ONSITE SEWAGE DISPOSAL SYSTEM PERMIT: CONSTRUCTION

PROPERTY ADDRESS: 14775 McCann Farm Road

SUBDIVISION: McCann Estates - West LOT: 2 TAX ID:

ON-SITE SEWAGE DISPOSAL SYSTEM

FOUNDATION	DATE: 06/25/22	FINAL LOCATION	DATE: N/A
DRAWN BY: GEL	CHECKED BY: GEL	SCALE: 1" =50'	
PROJECT NO.: 21-026	LOCATION DRAWING

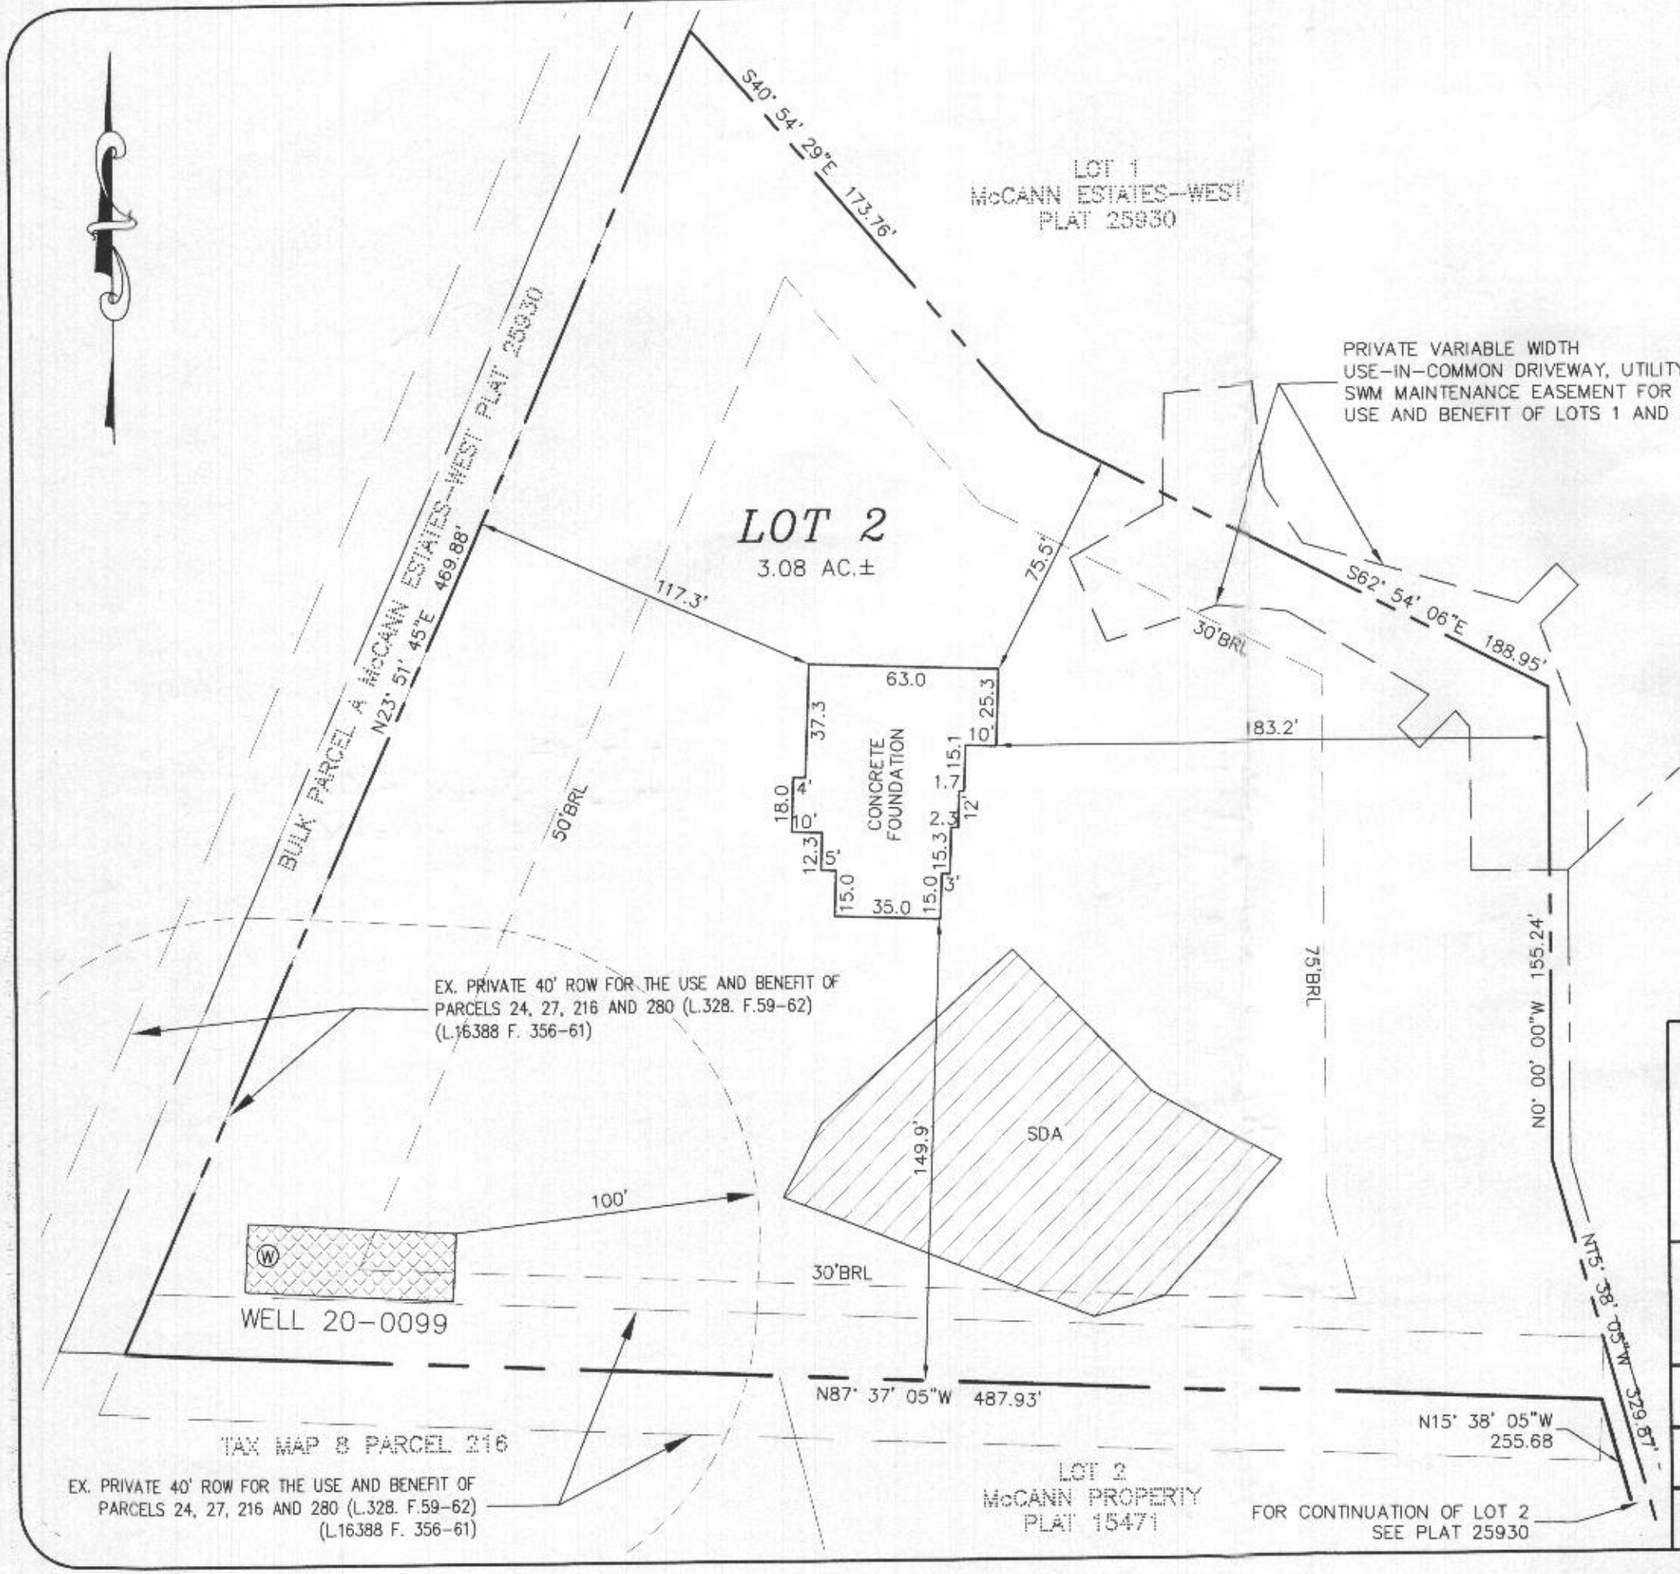
7/5/22
Will check o.k.
-Hank

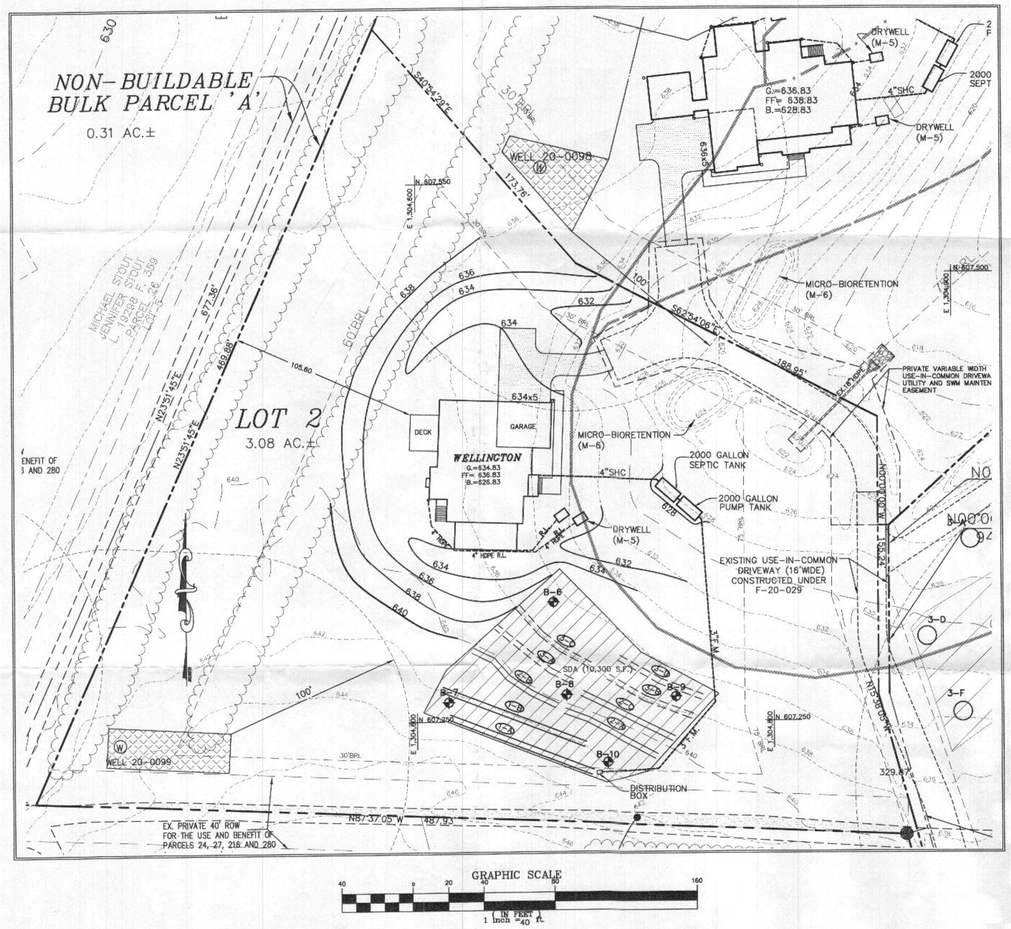
Good morning. The OSDS Plan for 14775 McCann Farm Road, McCann Estates – West Lot 2 has been reviewed with the following comments:

1. SDA may not be within 25 feet of steep slopes (greater than 25 %)
2. Tanks may not exceed 3 feet below grade.
3. Raise trench inverts to 2 feet below grade for better design
4. Add test hole #s to plan as well as SDA sq. footage
5. Label all stormwater management devices
6. 2nd replacement system rate is 0.8 (not 0.6)
7. Label calculation for emergency storage above high water alarm.
8. Clarify pump model information. Please note: Pump should not be a 230v model.
9. Initial calc 375 x .0.45 = 168.75, 375 x .4545 = 170.45

Good morning. It looks like the grading near DW M-5 is greater than 25 %. It looks to be between 33 and 36 % (see attachment). Can you please check it for me?

Attached are the revised OSDS plans for Lots 1 and 2 at McCann Estates-West, and the response letters to your comments dated October 22 . Three copies of the revised plans will be submitted this afternoon.
